Re: Expanded Environmental Notification Form, March 15, 2021 and May 11, 2021 Supplement
ADM TMUD Wareham Solar Projects
EEA No. 13940-ADM Tihonet Mixed Use Development
Wareham, Plymouth, Carver, Massachusetts

The Partnership for Policy Integrity (PFPI) submits the following comments on the Expanded Environmental Notification Form (“EENF”) EEA # 13940 to the Massachusetts Environmental Policy (“MEPA”) Unit. PFPI’s work focuses on forests and climate, and our involvement in state policy matters has up to this point largely been confined to biomass energy. However, we are very concerned at how the state’s policy on large-scale solar energy appears to be promoting projects that result in net damage to Massachusetts’ forests, and accordingly are submitting these comments on particular aspects of the Wareham solar projects.

Figure 1. Global Forest Watch overview of forest loss in the area of the project. The three proposed solar fields are marked with black dots.

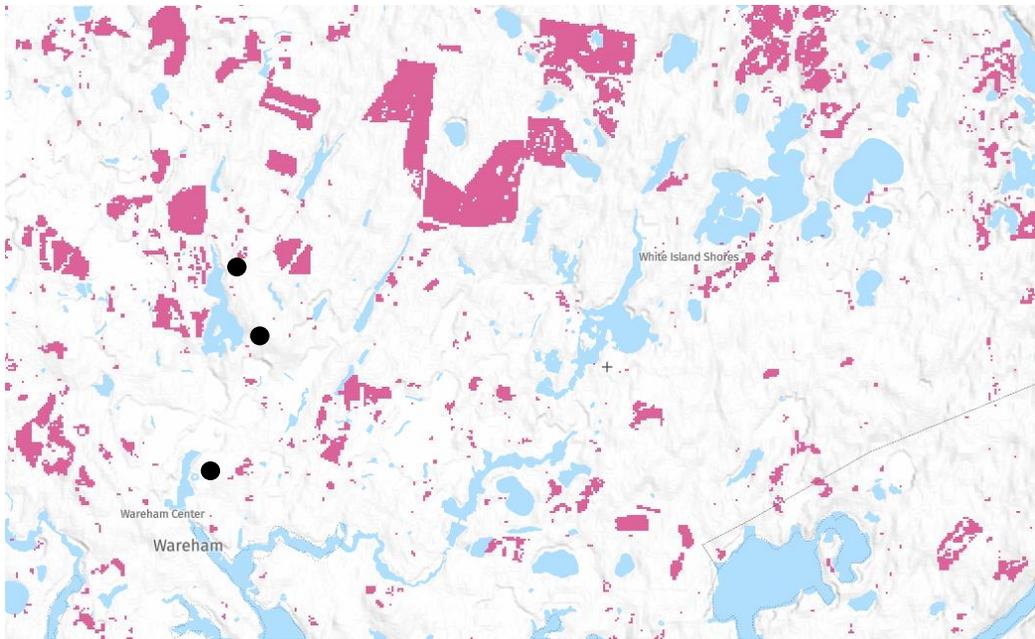
Satellite imagery from Global Forest Watch shows that forest loss in the vicinity of the project is particularly high. Figure 1 shows forest loss just since 2000¹; it doesn’t even include the large amount of conversion to cranberry bogs and other uses from before 2000. In fact, pulling back, this area appears to have one of the highest rates of forest loss since 2000 in the entire state of Massachusetts.

We wonder if the program would use similar language today. There is no “net” benefit given the accelerating forest loss in the region, as shown in Figure 1.

Figure 3. The graph of the relationship between diameter and area (square meters) overlaid on the proponents’ graph of diameter and volume (cubic meters) translated in some unknown way to weight of biomass.

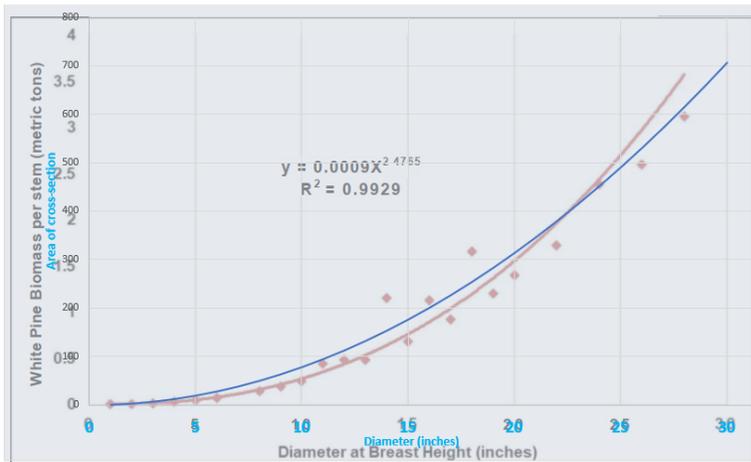
Given this failure and the proponents’ evident unfamiliarity with protocols for ecosystem carbon assessment, we have no confidence in the approach to calculating increased DBH and volume through time, which uses a “simplified, linear growth rate formula.” They do cite a reference for this approach, but it is not clear if their analysis of forest biomass takes into account the fact that trees with bigger circumference tend to also be taller, meaning their overall volume is greater. In fact, the regression curve that proponents provide for volume/weight (cubic meters) looks very similar to a standard curve of the relationship between diameter and area of a cross-section of a tree (square meters), which if the trunk is circular in cross-section would follow the relationship of “pi-r-squared.” We graphed up that simple relationship (in blue) and overlaid it on the on the proponents’ graph (Figure 3):

It appears that the proponents’ analysis of biomass per stem does not correctly reflect the overall increase in volume, because it traces a relationship of DBH to stem cross-sectional area, rather than full tree volume. Further, a stem analysis does not really tell much about forest biomass as a whole, unless there is a detailed count of stems per acre, and the analysis includes the volume of stumps and roots. Even with that information, the analysis of carbon *stocks* is incomplete, because it does not include soil carbon. For an analysis of future sequestration (carbon sinks), however, soil carbon may be difficult to quantify.

For a more credible approach, at a minimum the proponents could use the USFS Forest Inventory and Analysis data and tools that the Forest Service makes available for estimating forest carbon stocks and sinks. Additionally, research suggests carbon sequestration by larger, older trees has in some cases been

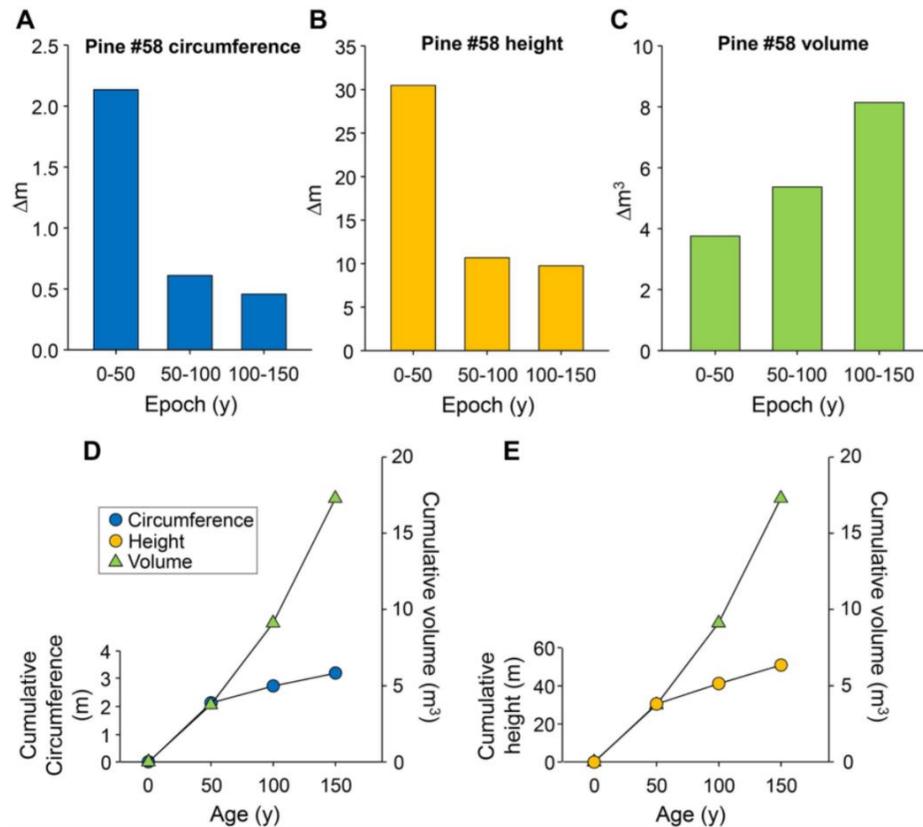
underestimated, for instance see Stephenson et al 2014⁵ and most recently Leverett et al 2021,⁶ with Figure 1 from that paper reproduced below. While growth patterns from individual trees can not be directly extrapolated to whole stands, the data suggest that the *apparent* “slowing” of growth by older trees is often not reflected in their volume, which continues to increase.
